Informal document No. 22 (85th GRSG, 21-24 October 2003 agenda item 1)

OICA PROPOSAL FOR DRAFT AMENDMENTS TO DOCUMENT TRANS/WP.29/GRSG/2003/18 UN/ECE R36 (BUS CONSTRUCTION)

Figure 8b
"Space for seated passengers behind a seat and or/or a seat facing the gangway (see paragraph 5.7.8.5.2)"

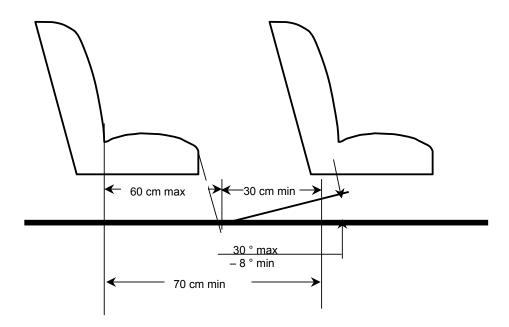
New inserted para. 5.7.8.5.2, amend to read:

"5.7.8.5.2. For a seat behind a seat and/or a seat facing the gangway, a minimum clear foot space of at least 300 mm depth and a width according to paragraph 5.7.8.1.1., reduced where appropriate by paragraph 5.7.8.6., shall be provided as shown in Annex 3, figure 8b. The local presence in this space of seat legs shall be permitted provided that adequate space remains for the passengers' feet. This foot space may partly be situated in and/or above the gangway but shall not create any obstruction when measuring the gangway-width in accordance with paragraph 5.7.5."

Insert a new drawing:
